Our Ref: J27035

28 February 2011

ESKOM ENVIRONMENTAL IMPACT ASSESSMENT (EIA:12/12/20/944) FOR A PROPOSED NUCLEAR POWER STATION AND ASSOCIATED INFRASTRUCTURE: COMMENTS ON THE DRAFT ENVIRONMENTAL IMPACT ASSESSMENT REPORT

Figure 1: Comparison of life-cycle greenhouse gas emissions of different electricity generation systems (Dones et al. 2003)

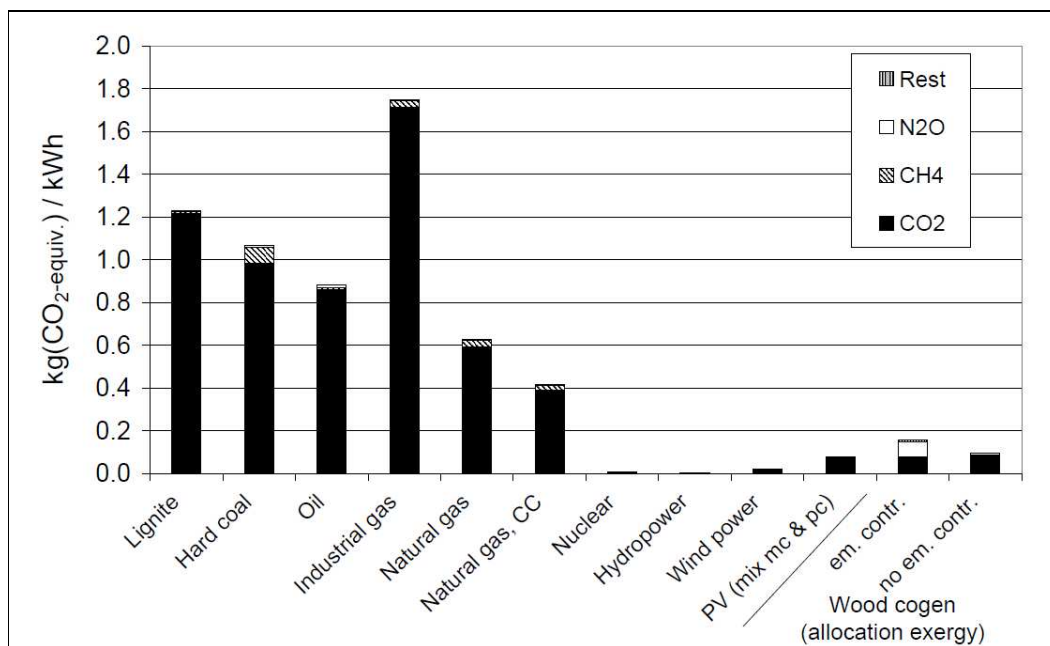
This EIA has been conducted in the context of current annual electricity production by ESKOM of approximately 40 000MW. ESKOM states that there is a need to ensure a doubling of this production in the next 20 years and is proposing generation of 20 000MW from nuclear. The current contribution to the annual production by nuclear from Koeberg is approximately 1 800MW, if at full capacity. The present EIA was amended in July 2008 to an application for a single nuclear power station of 4 000MW and ESKOM apparently hopes to embark on the process for further facilities following this process.

It is significant that there appears little consideration of the fact that some of the existing generation capacity will reach the end of its life span within the next few years and will require replacement. There is currently development underway of Medupi and Kusile coal-fired power plants both to produce 4 000MW each. This despite the continued concerns about the wide-ranging negative impacts from coal-mining, serious pollution caused by this mode of production and its effect on climate change concerns.

The current drive for development of nuclear is based on the suggestion that nuclear is a favourable technology in view of climate change concerns. This despite the fact that nuclear is not identified in the Kyoto protocol on climate change as a preferred alternative. The motivation in this context of nuclear is accordingly highly suspect.

Section 4.2.2 of the Revised Draft EIR contains a brief comparison of the life cycle greenhouse gas emissions of a number of different generation options, including nuclear, solar, wind and coal-fired generation. A life cycle analysis of the greenhouse gas emissions of these generation options indicates that nuclear power emits less than 11 grams of carbon equivalent per kilowatt-hour (gCeq/kWh) (Dones et al. 2003¹). This is the same order of magnitude as wind and solar power. This is also two orders of magnitude below (i.e. one hundredth of) the average for coal, oil, and natural gas. Apart from the benefit of lower greenhouse gas emissions, nuclear power generation does not emit sulfur dioxides (SOx), nitrous oxides (NOx) and requires much less water than coal-fired power stations. The figure below illustrates the rates at which different generation alternatives emit greenhouse gases.
